ADDENDUM NO. 1

BARNSTABLE
FAP NO. CRP-003S(984)X
Park and Ride Expansion and Improvements at Route 132

BARNSTABLE
PARK AND RIDE EXPANSION AND IMPROVEMENTS AT ROUTE 132
(610800-135580)

Questions and Responses

STATE	FED. AID PROJ. NO.	SHEET NO.	TOTAL SHEETS
MA	CRP-003S(984)X	34	87
PROJECT FILE NO.		610800

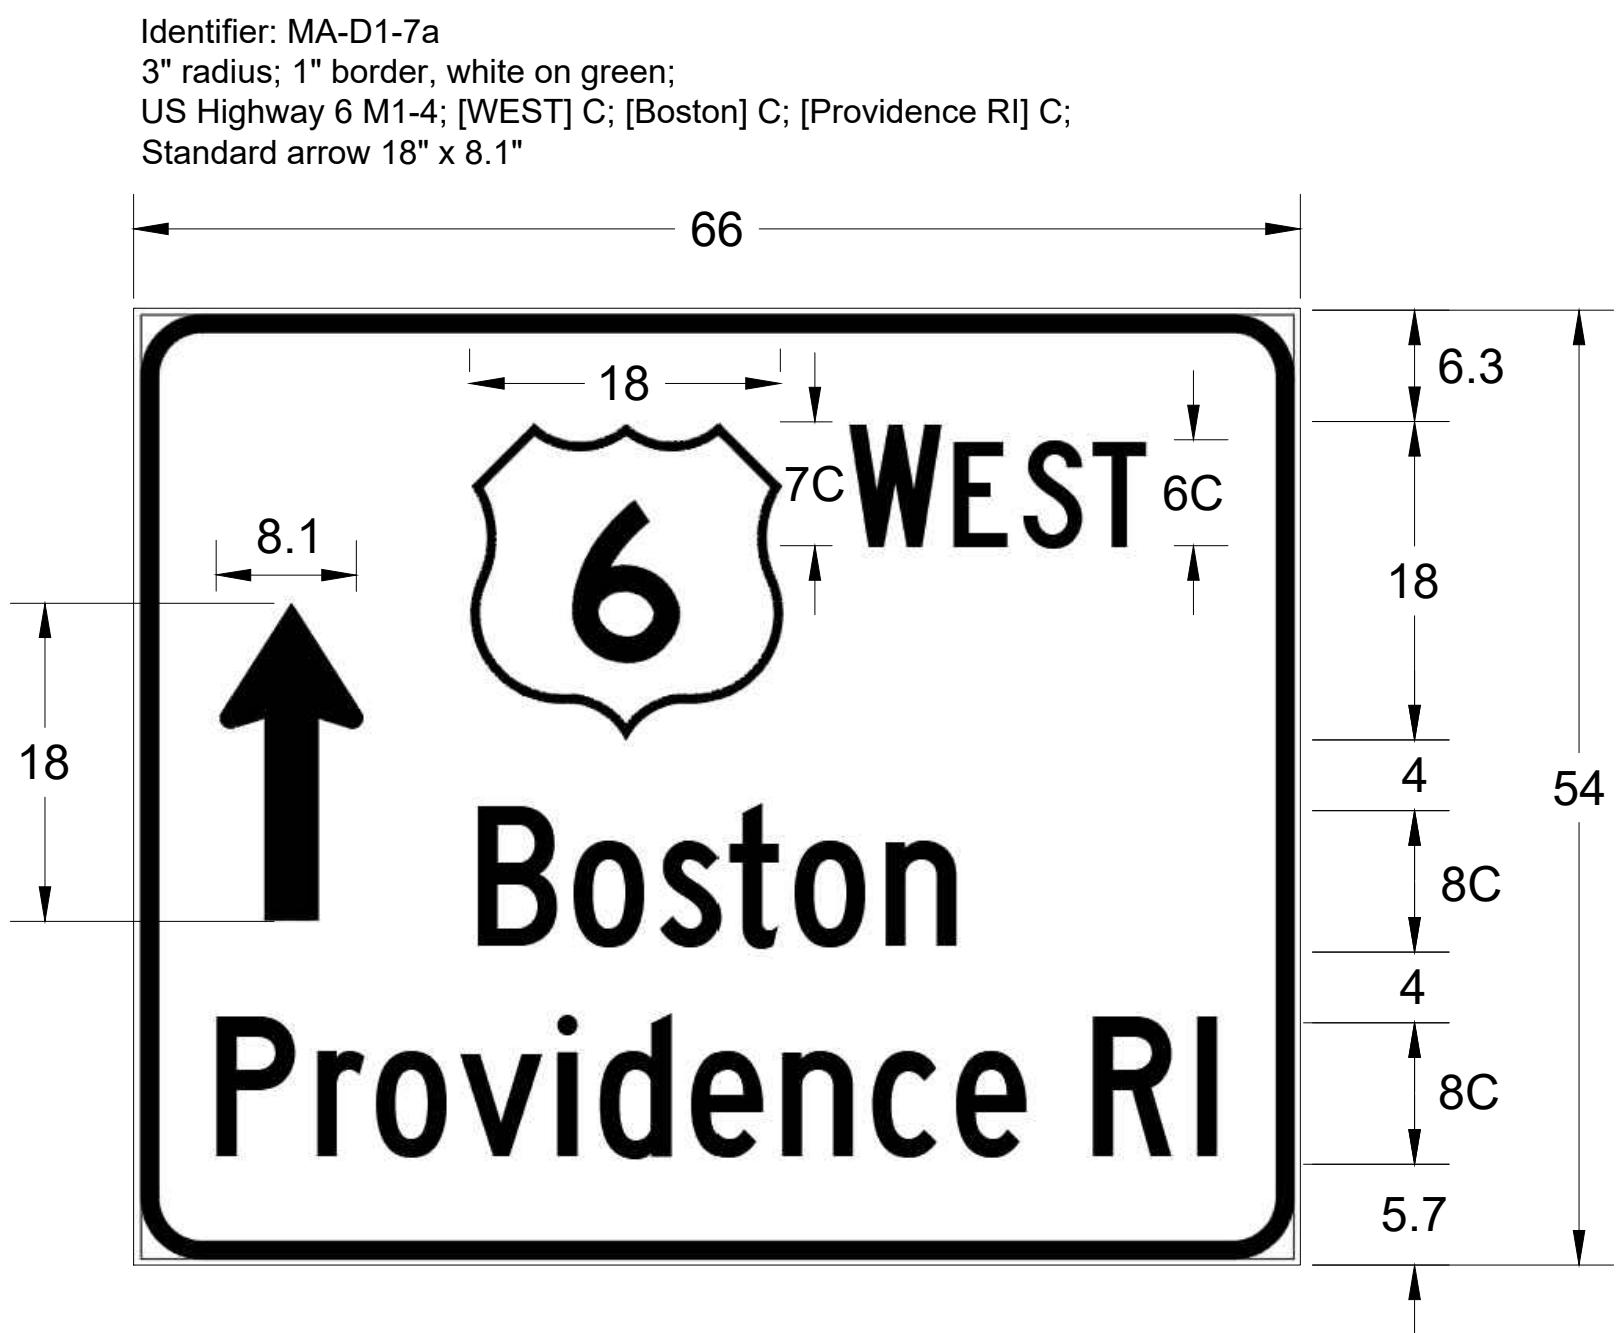
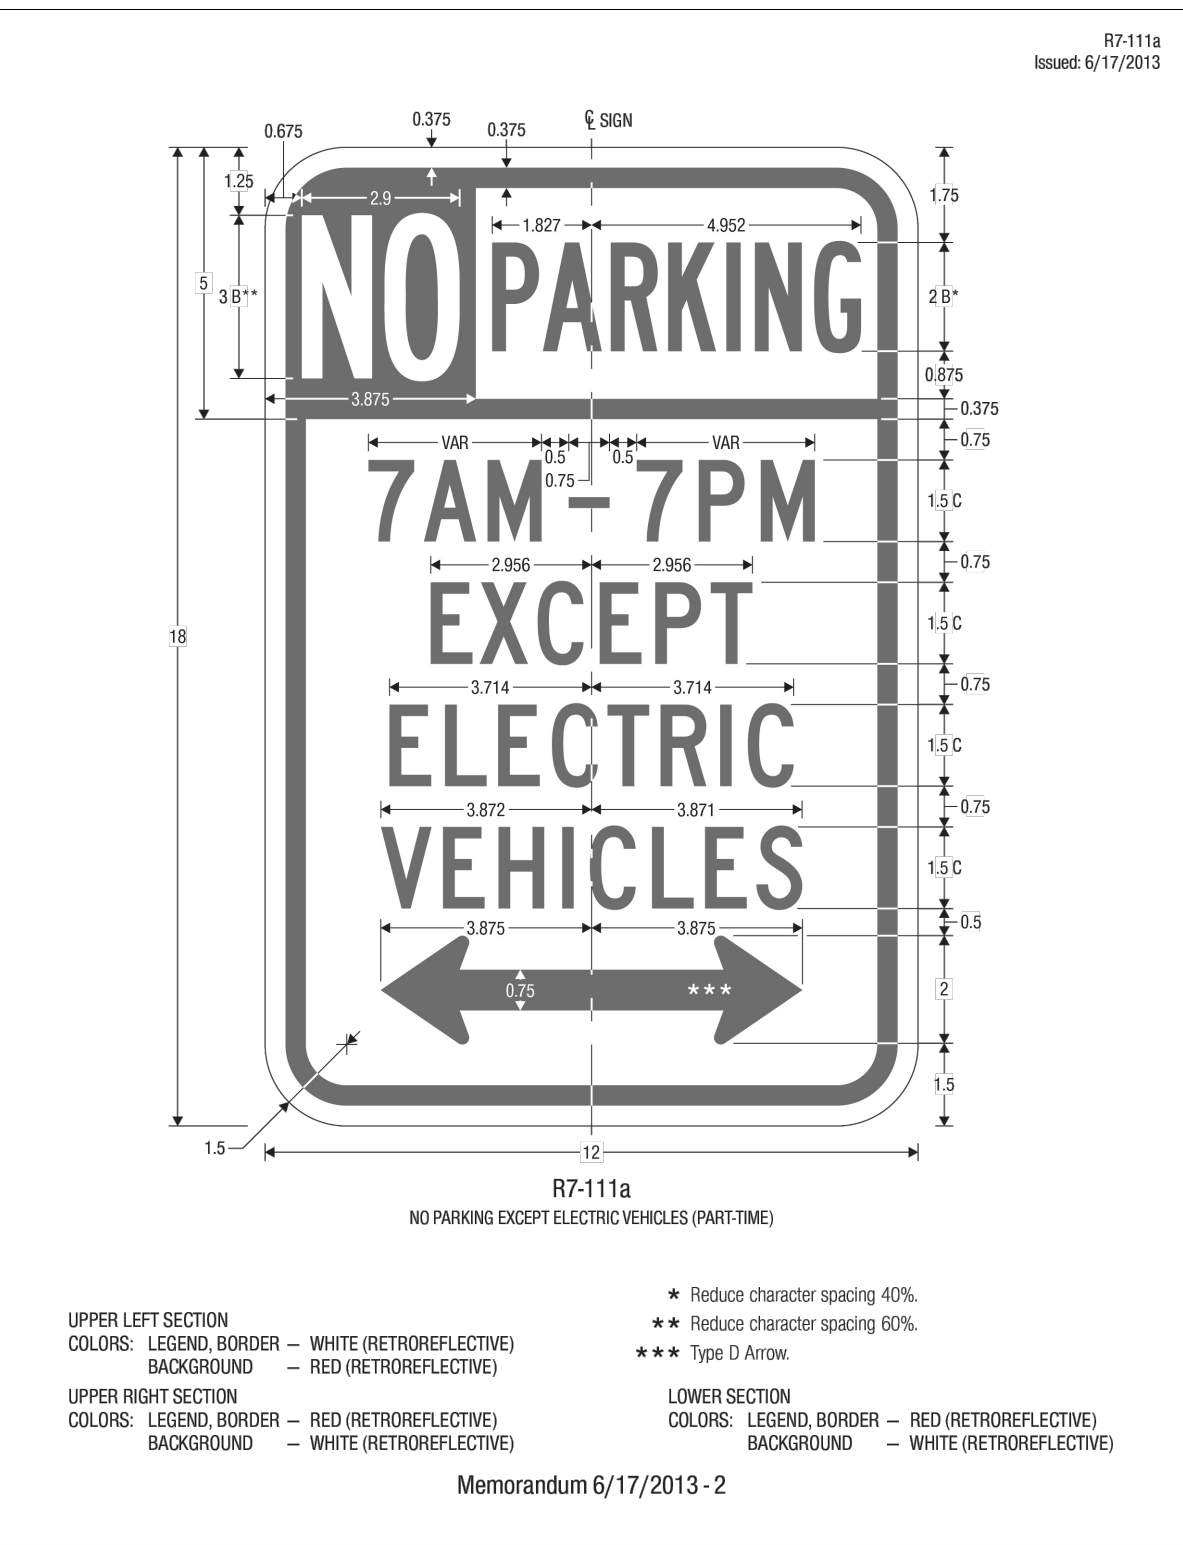
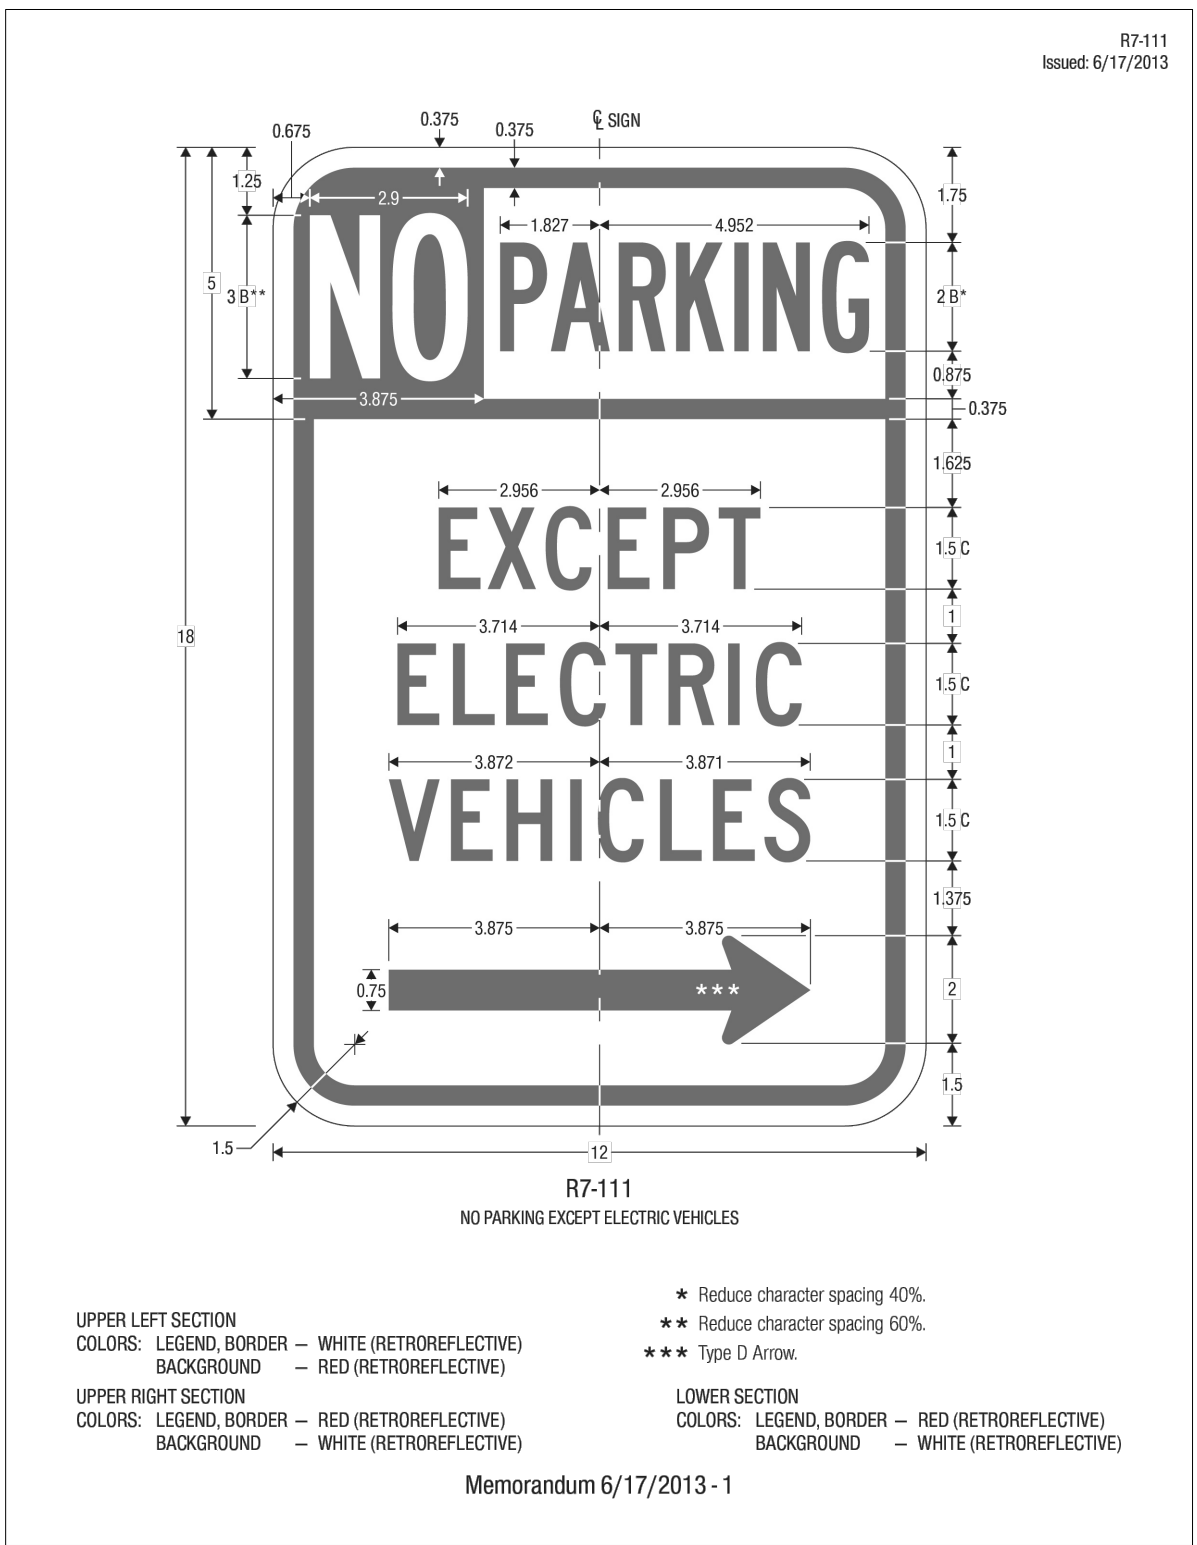
How tall are all the letters? There are different sizes on the plan.

Dimensions have been added for the letter heights on revised plan sheet 34 of 87.
